PROJECT	:	2 x 660 MW NTPC TALCHER TPP, STAGE - III
PACKAGE	:	COOLING TOWERS (CT) (NATURAL DRAFT COOLING TOWER)
ENQUIRY NO	:	PE/PG/HER/E-7118/2022 Dated. 26.11.2022
SUBJECT	:	PRE- BID CLARIFICATION

PRE-BID CLARIFICATION
[ENQUIRY NO. PE/PG/HER/E-7118/2022 DATED 26-11-2022]

NATURAL DRAUGHT COOLING TOWERS FOR 2 x 660 MW NTPC TALCHER THERMAL POWER PLANT, STAGE III AT TALCHER TOWN, ANGUL DISTRICT, ODISHA					
PRE-BID CLARIFICATIONS					
SI No	Reference			Queries	Response from BHEL
	Section	Chapter / Cl. No	Page No.		
COMMERCIAL					
1		21	1 OF 5	As cement and reinforcement steel are free issue items, BHEL should permit globalization of the cement and reinforcement steel quantities without affecting the sum total of the free issue items.	Bidder to follow Tender Specification.
2	Notice Inviting Tender	21	1 OF 5	In case bidder's quoted total cement and total reinforcement steel quantities are less than the specified respective base values, reduced quantities below the base values should be deducted from the quoted price at the specified evaluation rate for determination of the L1 bidder / Total Cost to BHEL excluding GST.	Bidder to follow Tender Specification.
3	Notice Inviting Tender	16

ANNEXURE-II (Revised co-ordinates and Battery limits)

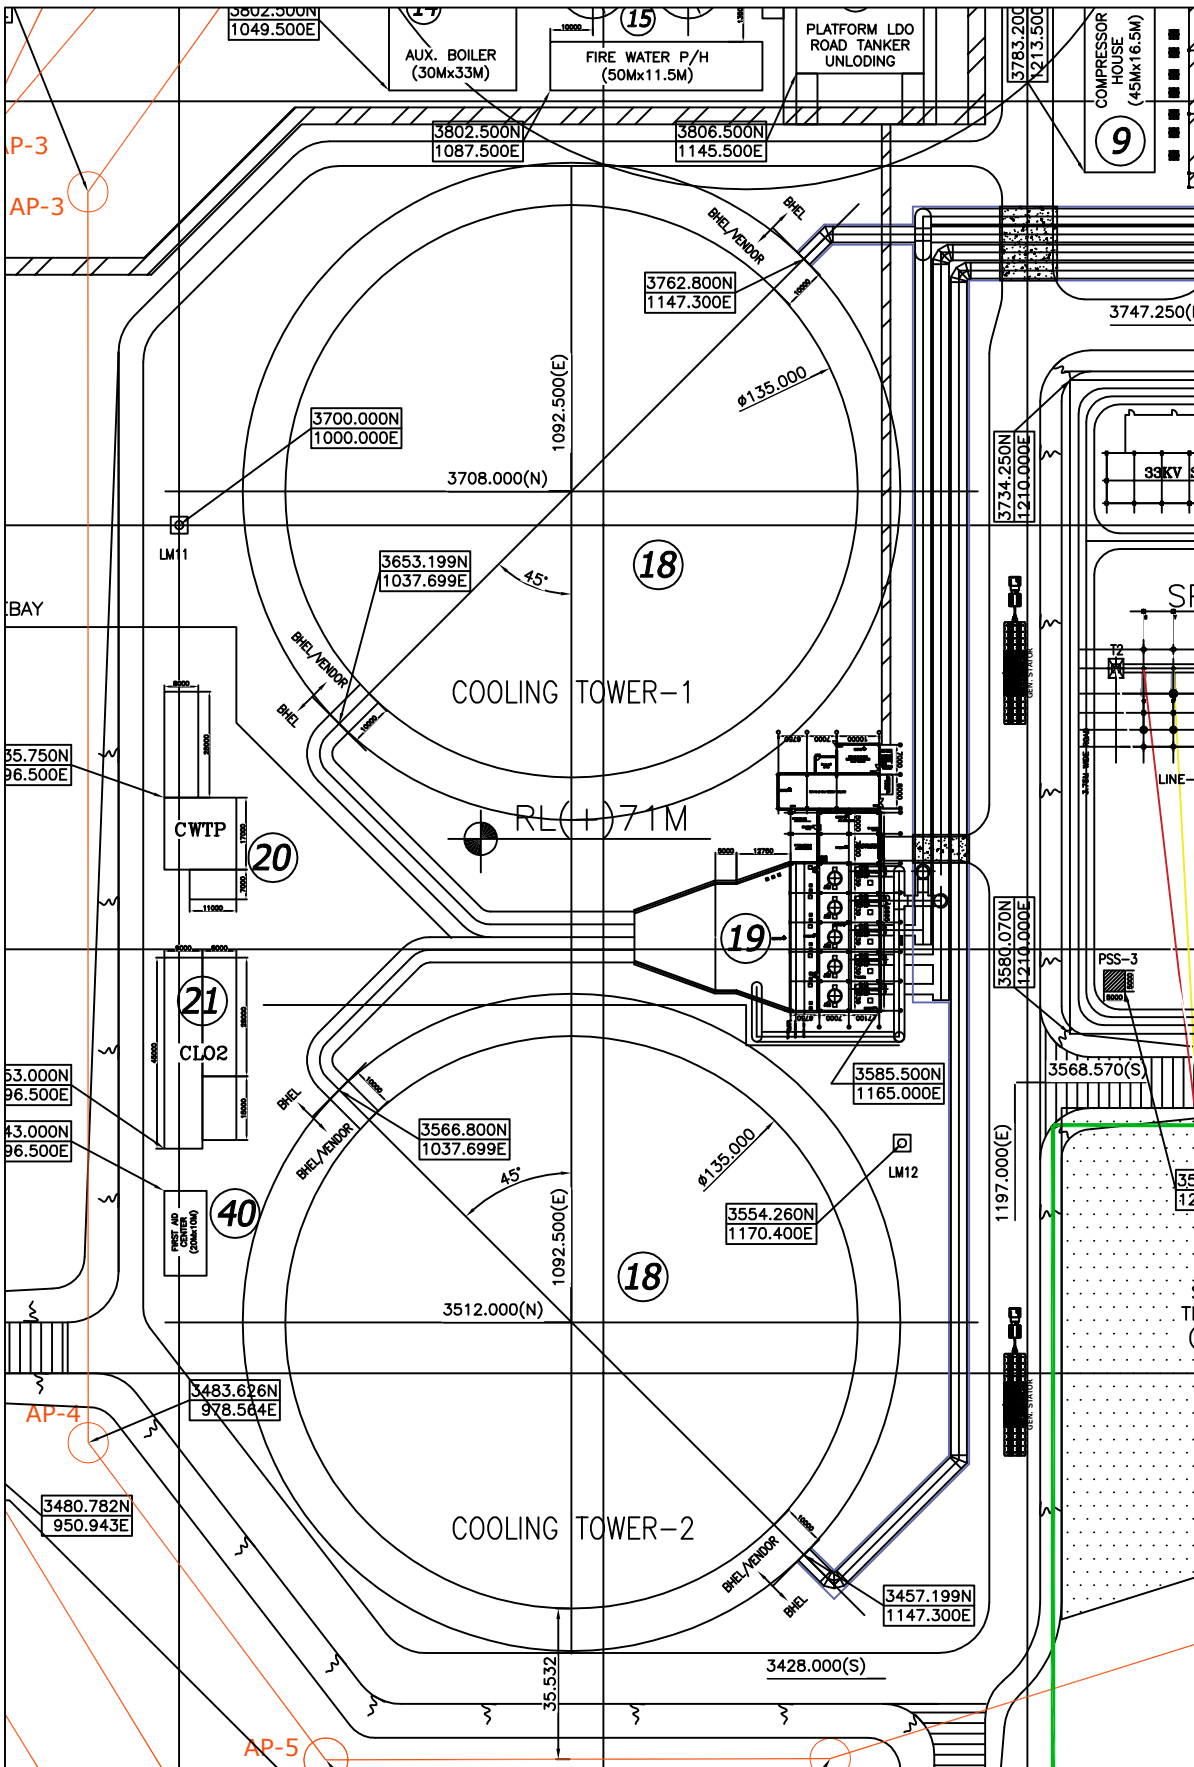
PRE-BID CLARIFICATIONS					
SI No	Reference			Queries	Response from BHEL
	Section	Chapter / Cl. No	Page No.		
6	Technical Specification No. PE-TS-497-165-N001	ANNEXURE-II / Layout Drawing	--	(a) Please provide NDCT layout drawing with related borehole numbers. (b) Battery limit under Vendor scope is not clear from this drawing. Battery Limits for Cold water Duct, Hot Water duct, Outlet Channel, Sludge Pipe to be clarified / marked clearly in the drawing for better understanding of our scope. The terminal points may be linked to the centre line of the NDCTs. (c) Location of the sludge pit needs to be marked in the drawing.	a) NDCT layout drawing with bore holes enclosed. b) NDCT layout with revised coordinates and battery limits is attached with this clarification. c) Sludgpit location shall be decided during detail engineering.
7	Technical Specification No. PE-TS-497-165-N001	Section VI / Part B of Bid Doc No CS-4540-001A-2 / Sub Section IID / Clause No 1.00.00	1 of 13	Kindly confirm that removal and disposal of identified facilities / structures / substructures / foundations of reinforcement, pavement/paving, pipes and any underground structure/materials, debris etc. are excluded from Cooling Tower contractor's scope.	Bidder's understanding is correct.

PRE-BID CLARIFICATIONS					
SI No	Reference			Queries	Response from BHEL
	Section	Chapter / Cl. No	Page No.		
22	Technical Specification No. PE-TS-497-165-N001	Section VI / Part B of Bid Doc No CS-4540-001A-2 / Sub Section IID / Clause No 5.18.03.02	83 of 120	Kindly furnish the distance of the disposal area from the excavation point. Kindly confirm that same should be located inside the plant boundary only.	Disposal area from excavation point shall be approximate 4 km.
23	Technical Specification No. PE-TS-497-165-N001	Section VI / Part B of Bid Doc No CS-4540-001A-2 / SubSection D-1-7 / Clause No 7.01.00	1 of 12	As per this clause, NGL is varying between RL (+) 64.9 M and RL (+) 67.0 M. But as per enclosed Bore Hole details for (BH-10 to BH-18) & (BH-149-157), NGL is varying from RL 71.425 M to RL 68.122 M. Please clarify why there is so much difference in the levels.	Please note that the variation of NGL mentioned in clause no 7.01.00 is for proposed Admin building, fire station, permanent store, Workshop building and gate complex area. Bidder is requested to refer bore logs of NDCT area for actual variation in NGL (for Bore Holes in NDCT area, refer attachment against SI.no 6(a) above).

1. THE ISOLATION VALVES FOR HOT WATER RISERS SHALL BE IN VENDOR'S SCOPE WITH RISERS TAPPED FROM WITHIN BIDDER SCOPE OF HW HEADER.
2. CENTRE LINE ELEVATION OF COMMON HEADER IS (-) 3.8 M.
